Amendment No. 51  
License No. DPR-43

AMENDMENT NO. 51 TO FACILITY OPERATING LICENSE NO. DPR-43

SAFETY EVALUATION BY THE OFFICE OF NUCLEAR REACTOR REGULATION  
RELATED TO AMENDMENT NO. 51 TO FACILITY OPERATING LICENSE NO. DPR-43

KEWAUNEE NUCLEAR POWER PLANT

FIGURE TS 6.2-1

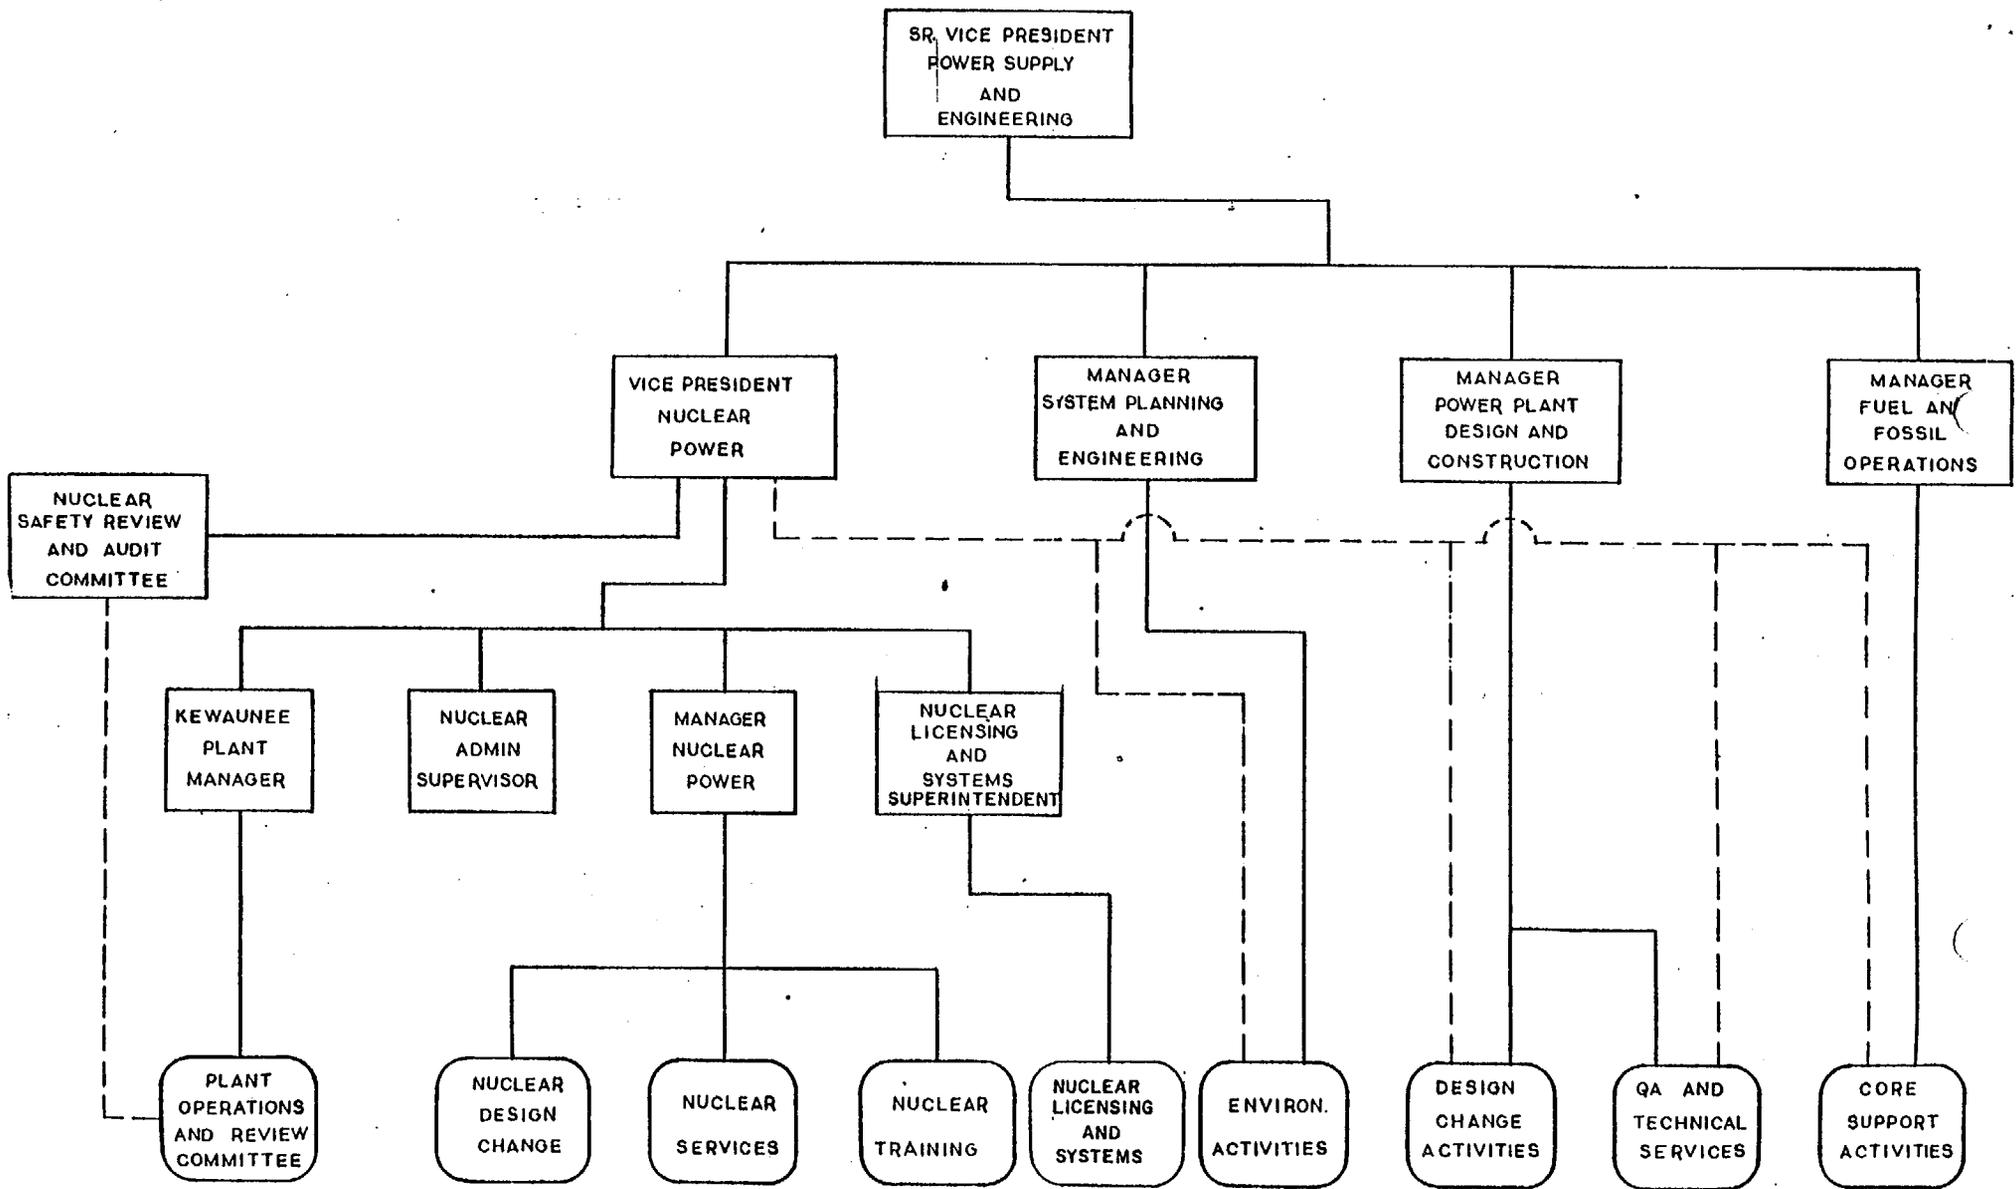
17. TS 6.2.2.a and 6.2.2.b has been revised to indicate that a Radiation Technologist has been added to each shift complement, and the allowances for his replacement should the need arise.
18. TS 6.2.2.e requirement has been deleted due to the additional requirement of TS 6.2.2.a.
19. TS 6.3.1 has been revised to reflect a staff position title change.
20. TS 6.5.2.4 has been changed to indicate that the Nuclear Licensing and Systems group is responsible to the Vice President - Nuclear Power.
21. Figure 6.2-1 has been changed to indicate the reorganization of the Nuclear Power Department.

The above changes 17 through 21 were made to reflect a reorganization of the Nuclear Power Department, the addition of an on-shift Radiation Technologist, and the title change of the Radiation Protection Supervisor. We have reviewed these changes and find they do not decrease the safe operation of the plant. The changes are therefore acceptable.
